# Plymouth Planning Commission

a. SP21-05: 1490 W. Ann Arbor Rd.: Scooter's Coffee, Revised Special Land Use and Site Plan Review

Re: 1490 W. Ann Arbor Road  
Special Land Use and Site Plan Approval Response

RE: Scooter's Coffee  
Sheldon Road  
Plymouth Township  
Wayne County DPS Plan Review: R 21-715

SITE LAYOUT PLAN  
**C2.01**

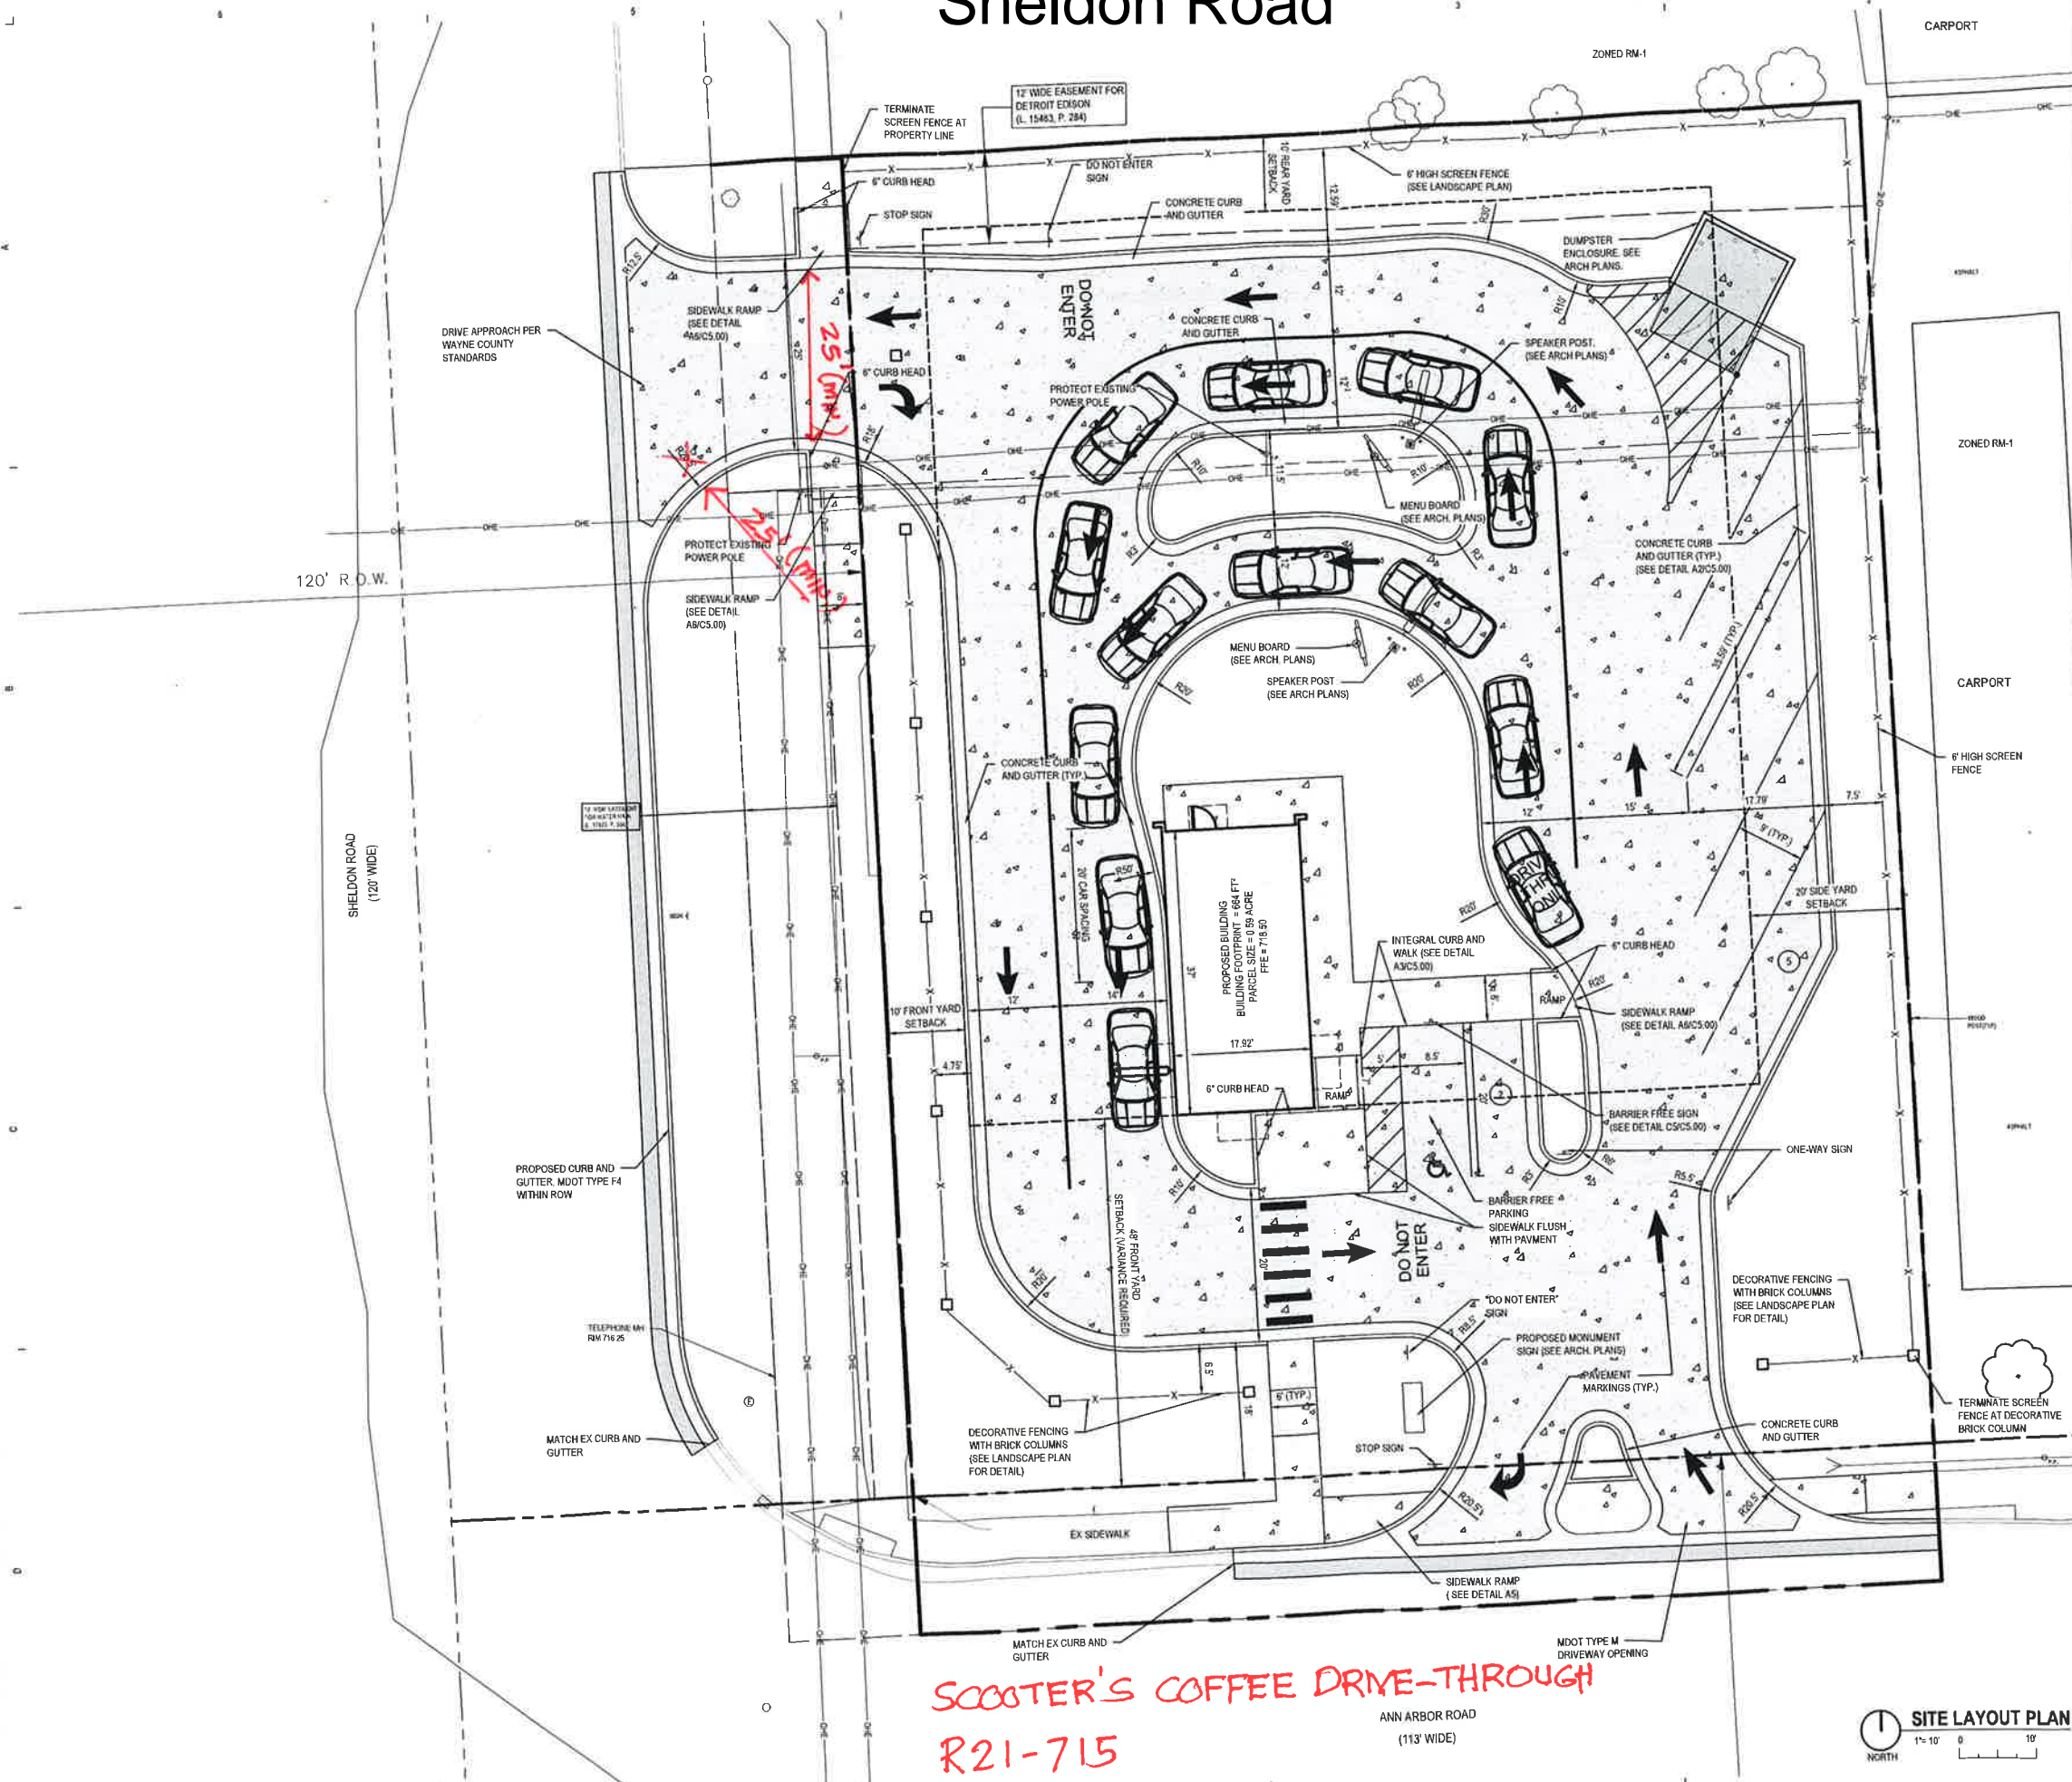
1. The 25 ft. throat width at R.O.W shown on plan Sht. C2.01 is showing face to face of curve. For the proposed curb and gutter section throat width at R.O.W must be 25 ft. (min.) clear travel width for two-way drive approach per Wayne County Permit Standard, D-6. Show and label on the plan. See sht. C2.01
2. The proposed 12.5 ft. outbound radius for drive approach on Sheldon Rd. is acceptable. The proposed inbound radius should be 25 ft. (min.) clear travel width.
3. The proposed traffic maintenance plan for one (1) lane closure on Sheldon Rd. should follow MDOT Maintaining Traffic Typical MO250a.
4. The sight distances shown on sht. C6.00 are acceptable.
5. The proposed drive approach and traffic maintenance plan on Ann Arbor Rd are not in Wayne County Jurisdiction.
